PL201900110
PL2019-110

Client
SKYWATER
TECHNOLOGY
FOUNDRY

Project
BUILDING
ADDITION

Sheet Title
CONCEPT
PARKING PLAN

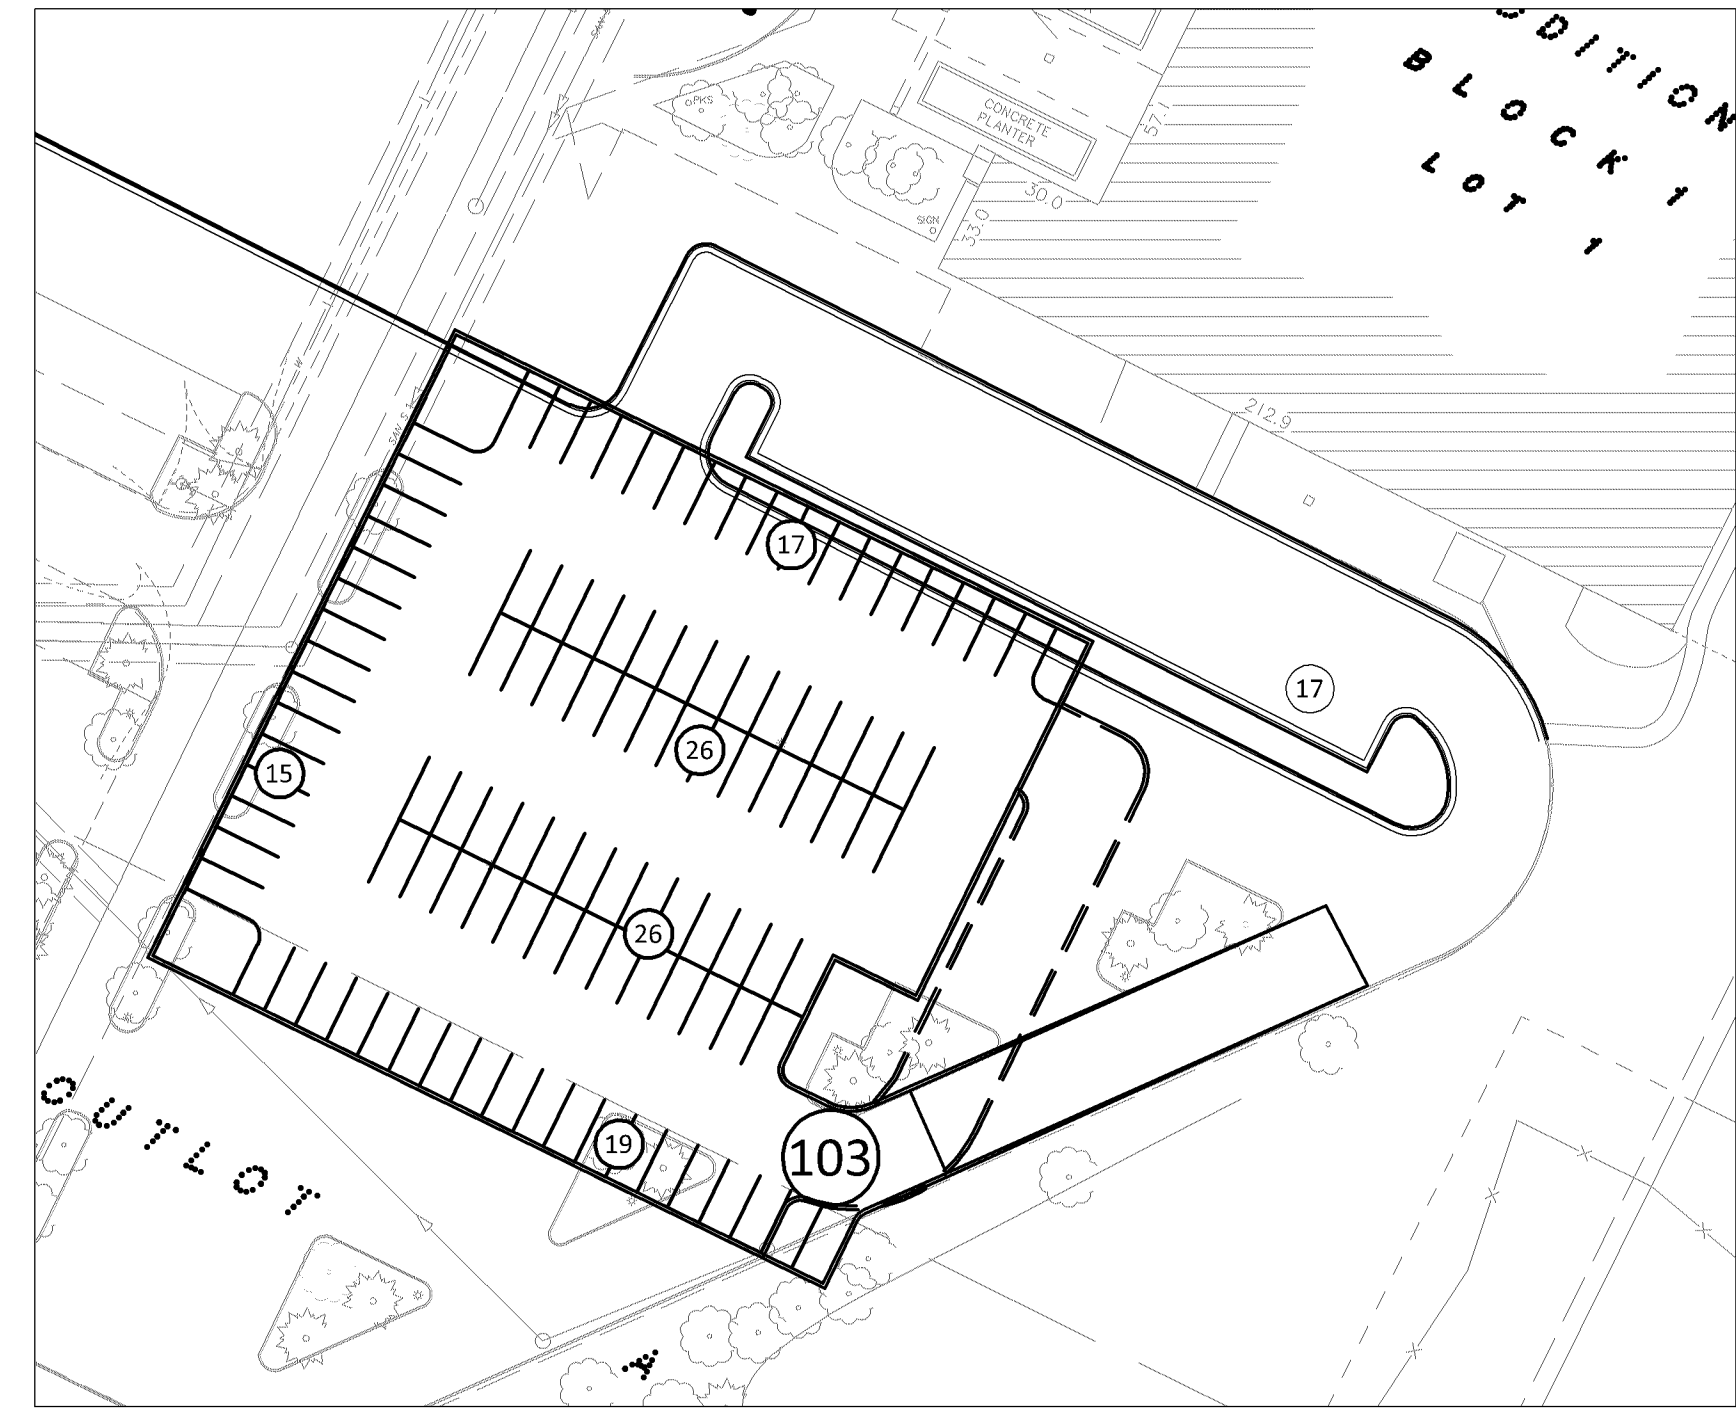
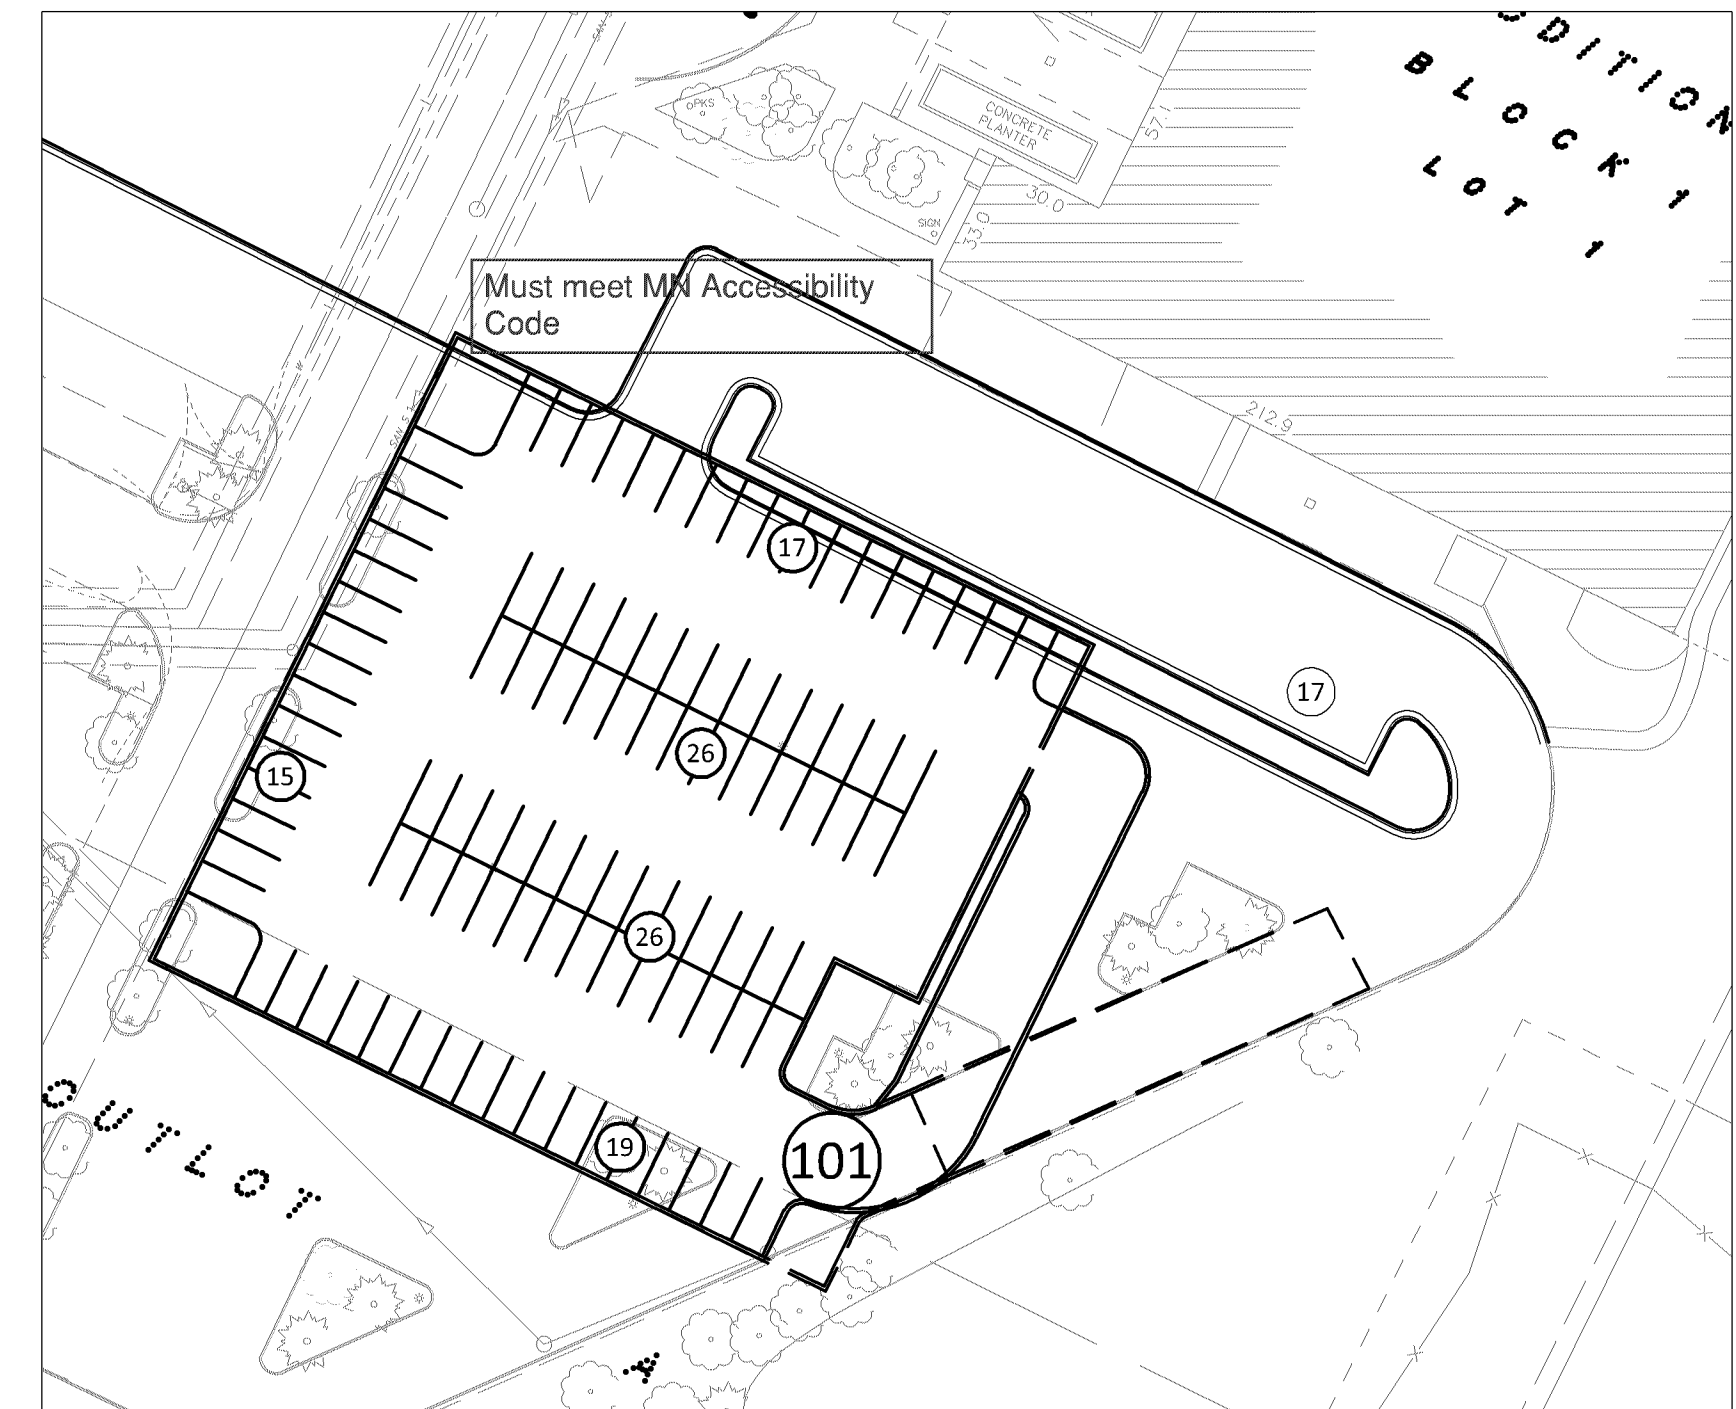
Provide for the new structure and maintain for existing structures emergency vehicle access throughout the property.

Provide adequate turning radius for BFD Ladder 3 for all emergency vehicle access lanes.

Must meet current MN State Building Code

Must meet MN Accessibility Code

SAC review by MET council will be required.

Plans must include a current building code analysis.

479 stalls is the parking requirement for the existing facility. The addition will increase the parking requirement. One stall per 500 square feet of "fab" space is required.
